Response to Submissions and Amendment Report

Infill Affordable Housing
Development – Edmondson Park
Block 20a

SSD-99909708

Figure 1: Proposed external louvres to windows to reduce potential for overlooking.

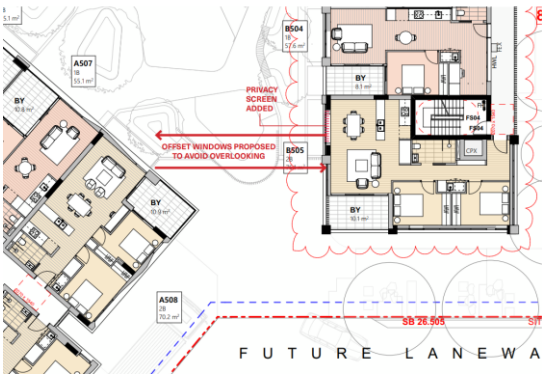
Issue Raised	Response
Building Separation	
Consideration being given to increase the proposed building separation distance between Building A and Building B at the southern junction and edge of the development boundary as the separation distances currently do not comply with the Apartment Design Guide (ADG).	The Design Team have reviewed the siting of the development especially the relationship of both buildings at the southern junction. Minimum separation distances between buildings is encouraged in accordance with Part 3F of the Apartment Design Guide (ADG). This section of the Guide aims to ensure the siting of the building/s maintain appropriate levels of visual privacy between properties. Design criteria require separation distances of a minimum of 12m between buildings up to 4 storeys and 18m (5-8 storeys). Building A and Building B at the closest point have a

total of 9.3m which fails to comply with the minimum separation distances.

The design has been refined to ensure windows openings and balconies are offset and an external angled louvred privacy screen is proposed to the lounge room window to the southern most units in Building B (205, 305, 405, 505, 605, 705 and 805) as shown in Figure 1 below. The balconies to these units already include privacy louvres which will restrict any overlooking. Figure 1 below shows the proposed design response to this issue.

The proposed design of the buildings relies on less separation at the southern edge and junction however aims to be articulated and modulated and the building siting aims to ensure as many units as possible are orientated towards the north and north-east maximising solar access. Many design and built form concepts were considered for the design but given the awkward allotment layout the siting creates a more interesting design that considers the constraints and aligns with the fan shaped allotment shape. The proposed design satisfies the objective of part 3F-1 of the ADG which promotes “adequate building separation distances are shared equitably between neighbouring sites, to achieve reasonable levels of external and internal visual privacy”. The control is focused on maintaining privacy between sites not within sites however the issue is around ensuring ‘reasonable’ levels of privacy are maintained. The use of screening and offsetting windows and orientating openings to be directed sited away from adjoining buildings is promoted through the design and the response adequately addresses the control. It should be noted that it is only a small section of the development that is more closely located whilst the majority of the development is compliant with the ADG separation distances.

Figure 2: Level 01 Building B floor plans (As Exhibited)

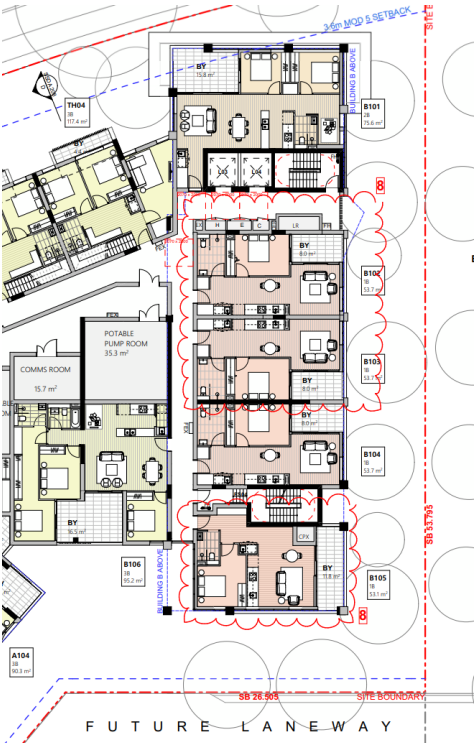
The main refinements are internal changes to kitchens, WC and living spaces making the internal amenity more functional and spacious. At Level 1 the main physical change is that the central apartments have their balconies and living spaces flipped as this creates a more standardised design and will be easier to construct. The size of units remains largely the same with slight increases in depth due to some service areas being dedicated as habitable space.

Figures 2 and **3** below compare the original scheme with the amended one at Level 01 Building B.

Figure 4: Levels 3-8 Building B typical floor plan (As Exhibited)

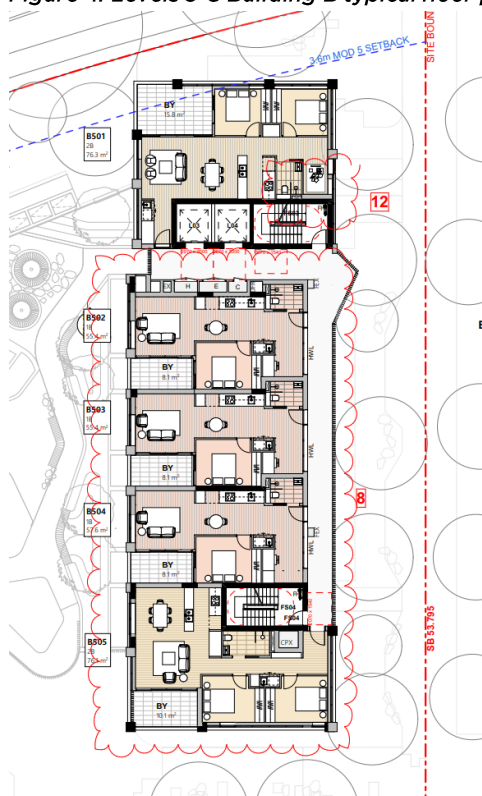
Changes at levels 2 and 3-8, Building B are similar to Level 01. **Figures 4** and **5** show the layouts and compare these to the original design. At Level 2 apartments have been flipped with balconies relocated which aims to improve internal circulation and the amenity of key spaces. At level 2 to level 8 centrally located apartments have been able to integrate a small study adjacent to the entry. This small study space is a very efficient inclusion and will add value to the units in terms of improving their functionality.

The changes do not alter the depth of the building, nor do they significantly affect the key metrics of the scheme. The increase in the floor space by 106.7sqm is considered minor and doesn't affect the bulk or scale of the building as the space was previously services and plant which were excluded from the GFA calculation and its conversion to habitable floor space means the area is now included in GFA. It's a minor addition and will not facilitate any significant change to the built form.

Figure 6: Building B internal elevation (As Exhibited)

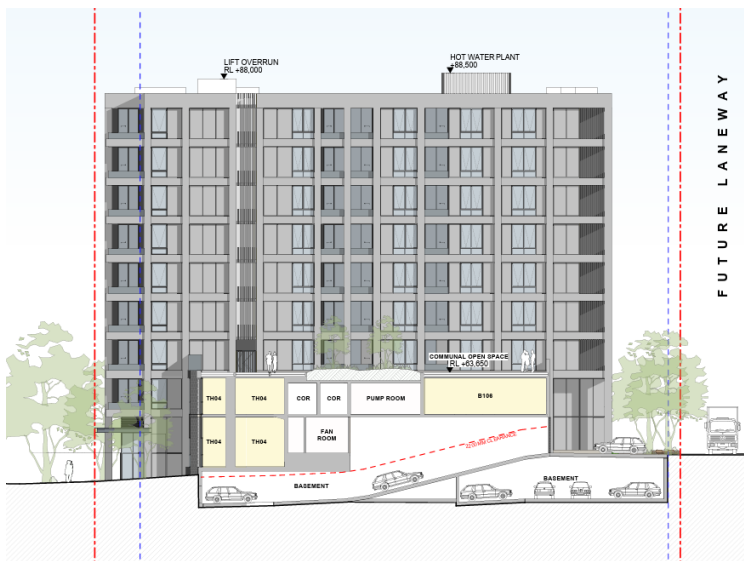
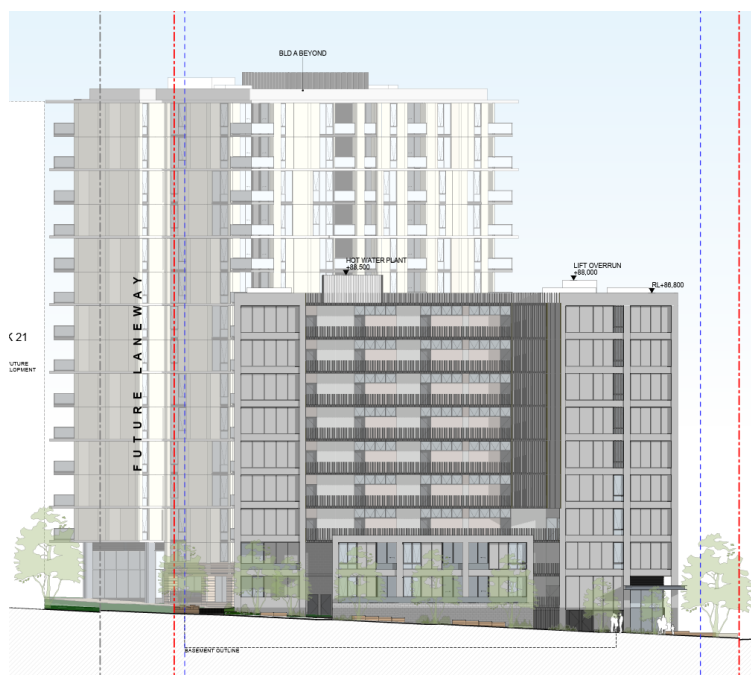
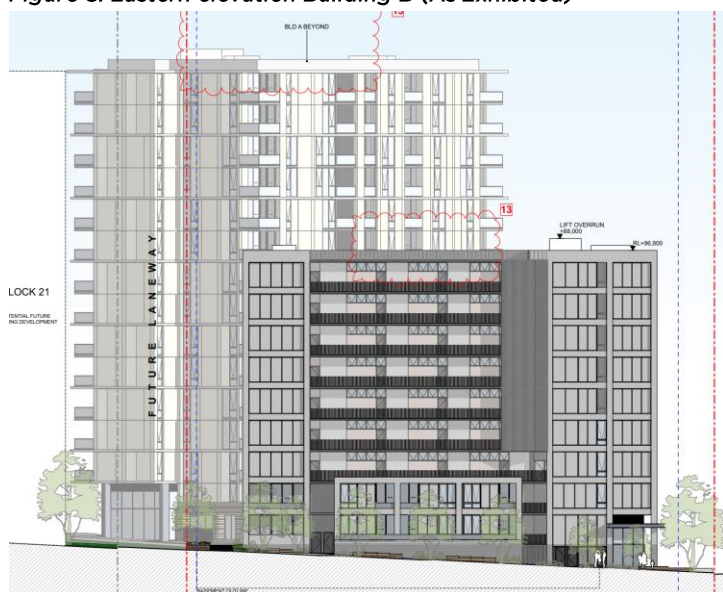
The internal changes to the apartments in Building B and the relocation of balconies will have a slight impact to the external façade of the building as the balcony openings have been relocated. **Figures 6 – 9** compare the elevations as originally proposed and as amended. The building maintains the strong articulation through the use of openings, materiality and finishes and retains symmetry and balance.

Figures 6-9 also show the reduction in the overall height by the removal of the central hot water system from the roof which will reduce the overall height of both Building A and B by 500mm.

In respect to height, the overall height has been reduced by 500mm for both buildings as the central hot water system has been removed which previously was located on the roof and was the highest point. The removal of this element reduces the overall height as can be seen in the elevations shown at **Figure 7** and **9**.

Figure 10: Comparison of the Ground floor landscape changes (courtesy: Taylor Brammer)

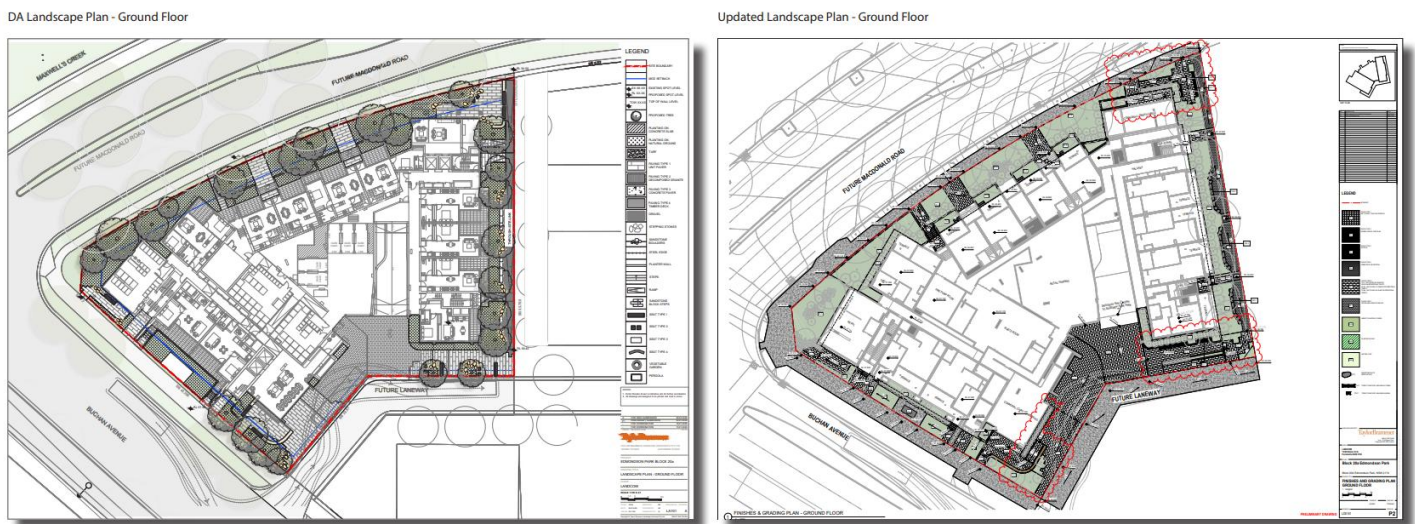
- Minor layout changes to the area of communal open space including retaining wall realignments, seat relocation and associated paving extension. These aim to create a better pedestrian environment and improve accessibility and safety when utilising the BBQ and associated seating area.

- Additional low scale planting around the perimeter of the communal area.
- Landscape design levels and layout are updated near building entries and an accessible entry ramp and stair provided to accommodate slight level changes. Additional low scale landscaping is provided along the laneway and rear of the building and along key edges.

- While there are no real changes to the type of landscape species and arrangement and layout of landscaping elements, there is increased landscape treatment around the periphery of the buildings and around the electrical substation to provide low scale greenery, buffer planting and screening to soften the appearance of the substation structure when viewed from the adjacent units.

- While some trees have been removed, they have been replaced/relocated in other parts of the development, and the overall tree canopy has increased.

Figure 10 below is an extract comparing the changes at the ground floor level. A full set of updated landscape plans can be found at **Appendix E** and an explanation of the design variations are provided at **Appendix F**.
